WESTERN HARBOUR TUNNEL AND BEACHES LINK

ALTERNATIVE PROPOSAL

CURRENTLY PROPOSED PORTAL AND EXHAUST STACK LOCATIONS

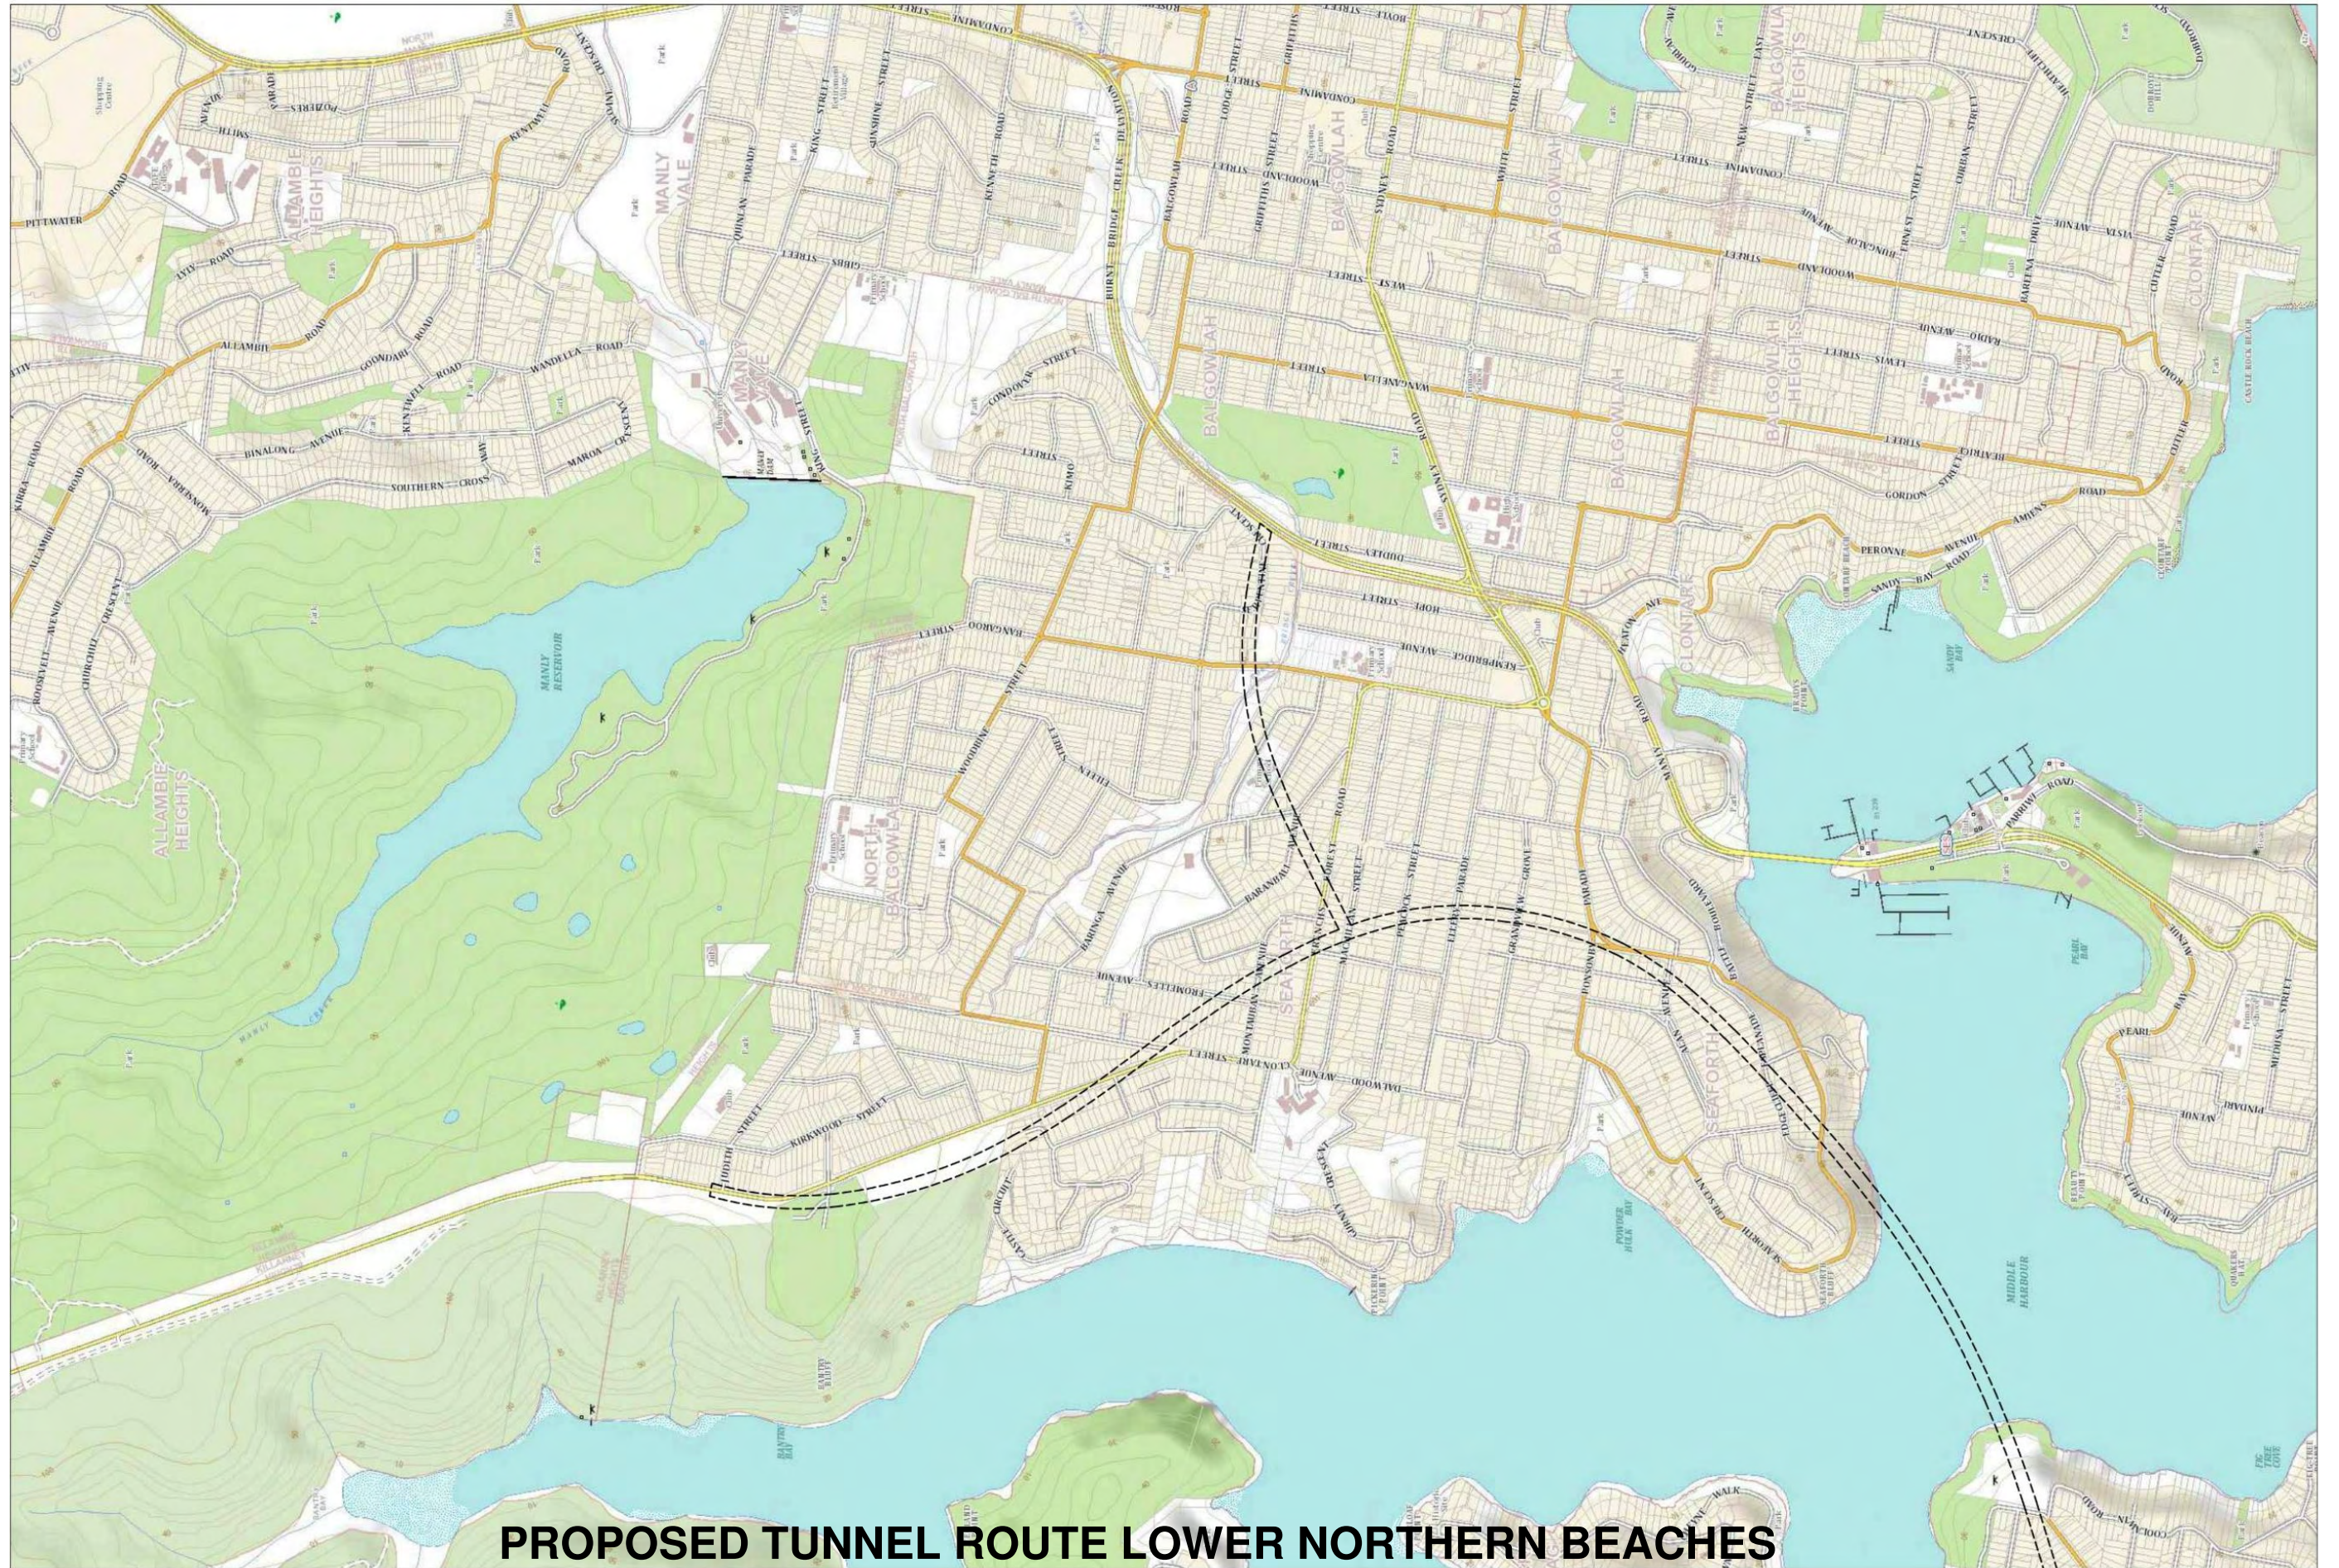
These exhaust stacks were shown close to homes and schools. In the case of the Balgowlah exhaust stack and portal, this was shown within 150m of Seaforth Primary School.

2. The impact of Tunnel Exhaust Emissions. The North Seaforth tunnel exhaust stack is currently shown immediately adjacent to an established residential area and Seaforth oval. These impacts can be avoided if the tunnel portal and exhaust stack are simply relocated further north along the Parkway.

2 Unacceptable Impacts of Exhaust Emissions. - Not only is the proposed exhaust stack within close proximity to existing houses and immediately adjacent to Seaforth Primary School, it is located at the low point of a valley that is known locally as a trapped low point. The prevailing winds are from the ocean (northeast and south east). The existing ridge to the west of the valley will block emissions from clearing from the trapped low point in all but relatively windy conditions. Exhaust fumes from the Balgowlah portal will be emitted from the Balgowlah exhaust stack continuously, 24 hours a day, 7 days a week. This will have the impact of concentrating exhaust emissions within this trapped low point. The trapped low point extends from Seaforth to Manly and up to Brookvale and North Curl Curl. The area includes North Balgowlah, Balgowlah, Manly Vale, North Manly, Freshwater, Queenscliff, Curl Curl, North Curl Curl and northern parts of Fairlight and Manly. This is a densely populated residential area containing several (at least 12) schools and numerous kindergartens and day care centres containing approximately 10,000 students. It was also noted in the leaked RMS document that there are concerns with "Plume Downwash entering nearby homes"

3 Seaforth Primary School is immediately adjacent to both the proposed Tunnel Portal and Exhaust Stack. The proximity of any school next to infrastructure of this nature is would be considered unacceptable by any community. Seaforth Primary would also be particularly susceptible to exhaust emissions from the tunnel exhaust stack as Seaforth Primary is downwind of the exhaust stack.

ASSUMED HARBOUR CROSSING OPTIONS

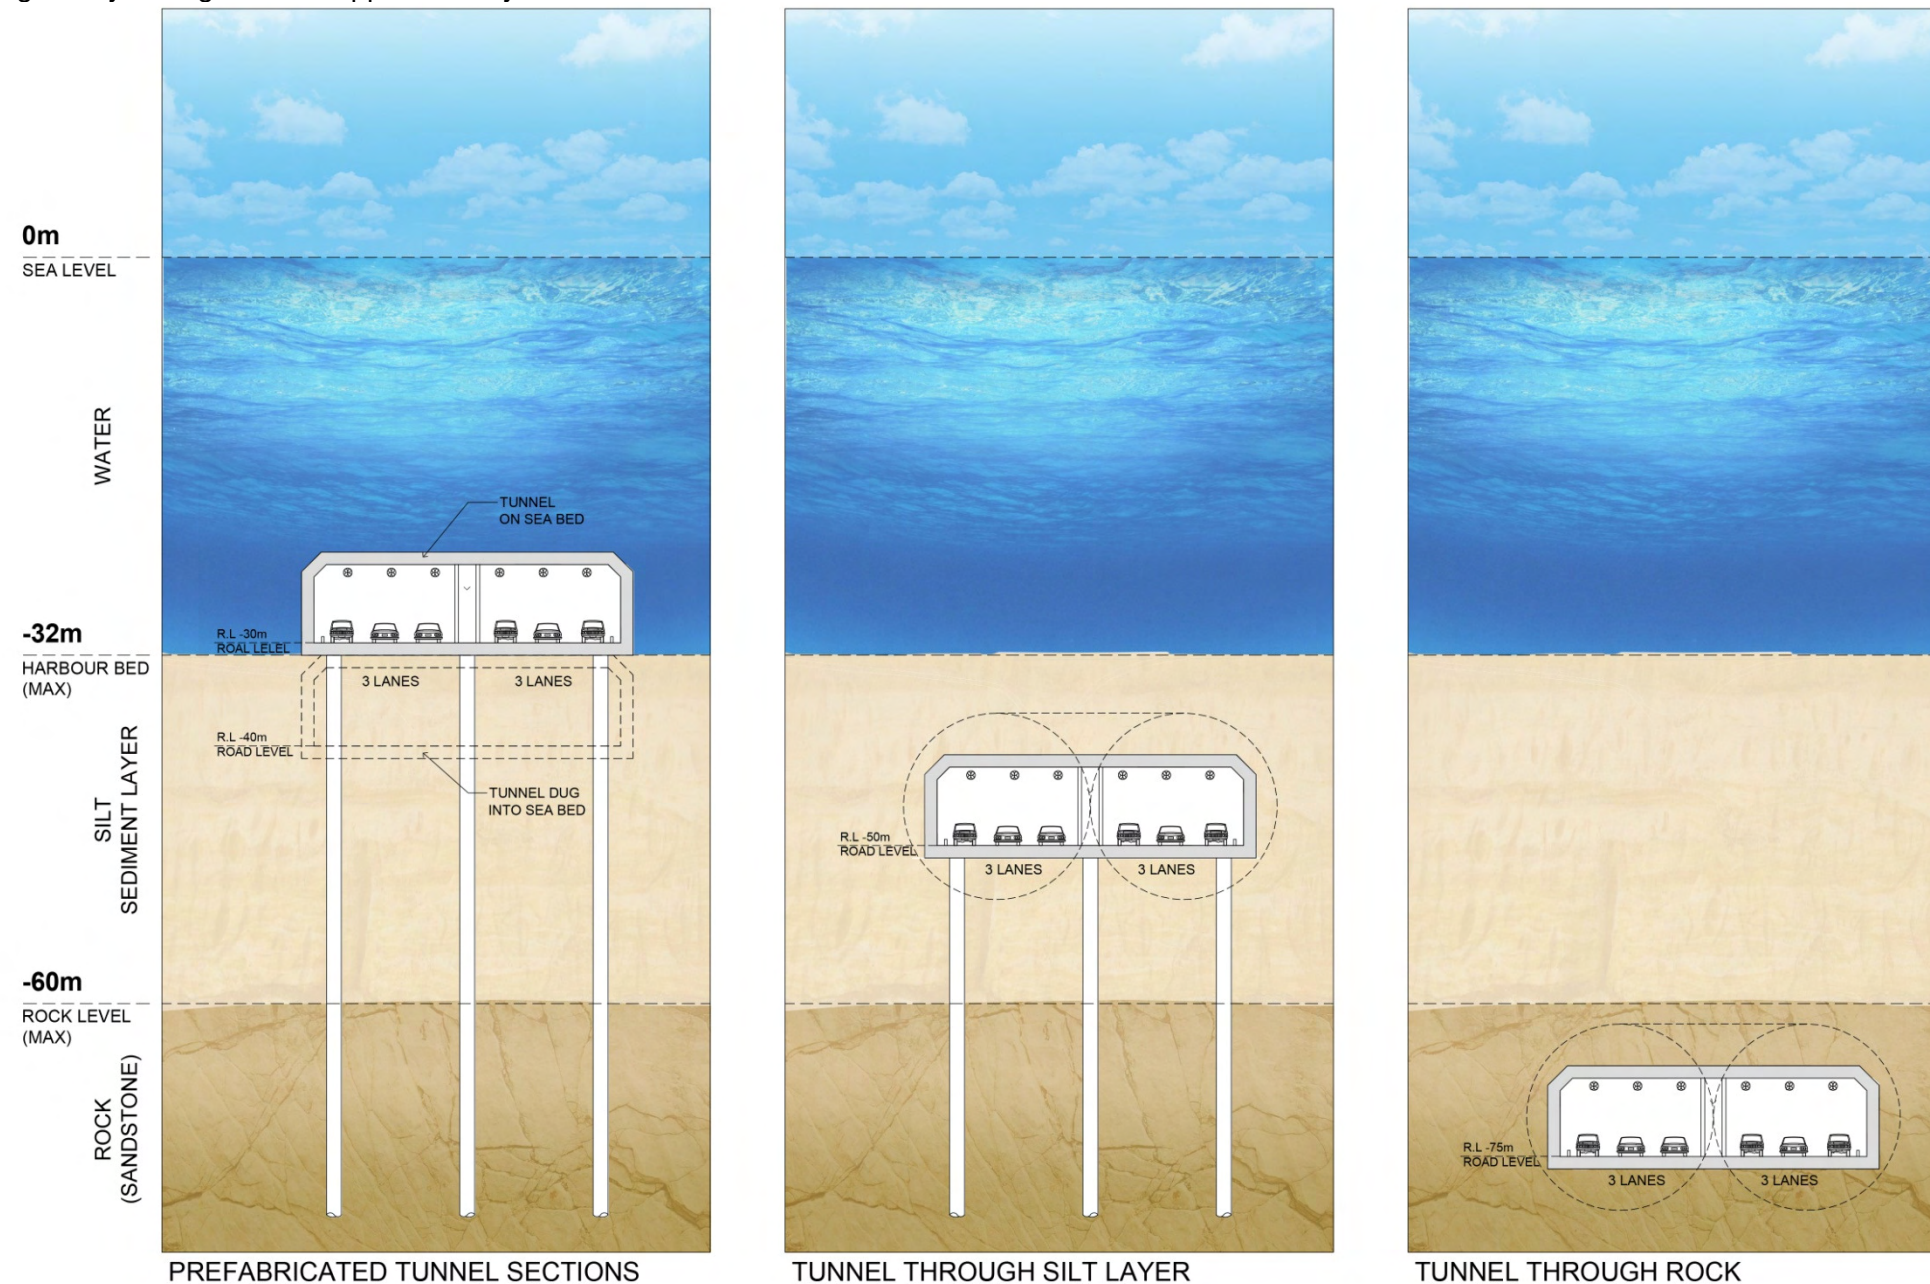
The immersed tube harbour crossing option is the least environmentally sensitive option. It will require the construction of coffer dams within middle harbour to join the immersed tubes at either end, and will disturb the silt layer at the bottom of the harbour during dredging works required to place and secure the tunnel segments. It will also cause considerable disruption within middle harbour and will further require the use of foreshore land (either private or public) as construction sites from which the construction works would be staged. It is noted that no harbour crossing has been permitted using immersed tube construction since the Sydney Harbour Tunnel was completed in 1992. The recent metro rail tunnel proposal initially proposed an immersed tube crossing as the preferred method of crossing the harbour. This method was rejected on environmental grounds (stated in the final business case summary dated October 2016). A bored tunnel option is currently being utilized for the new metro rail harbour crossing.

1. The immersed tube harbour crossing is more environmentally intrusive method of constructing the Harbour Crossing. A less disruptive method would be to select a bored tunnel option. The immersed tube crossing option is being proposed to minimise the length of tunnel between the Harbour crossing and the North Seaforth Portal.

A bored tunnel harbour crossing option would require the tunnel to be at least 20m deeper than an immersed tube option. At the maximum 4% grade the tunnel would need to be extended at least 500m further north of the current location proposed for the North Seaforth portal.
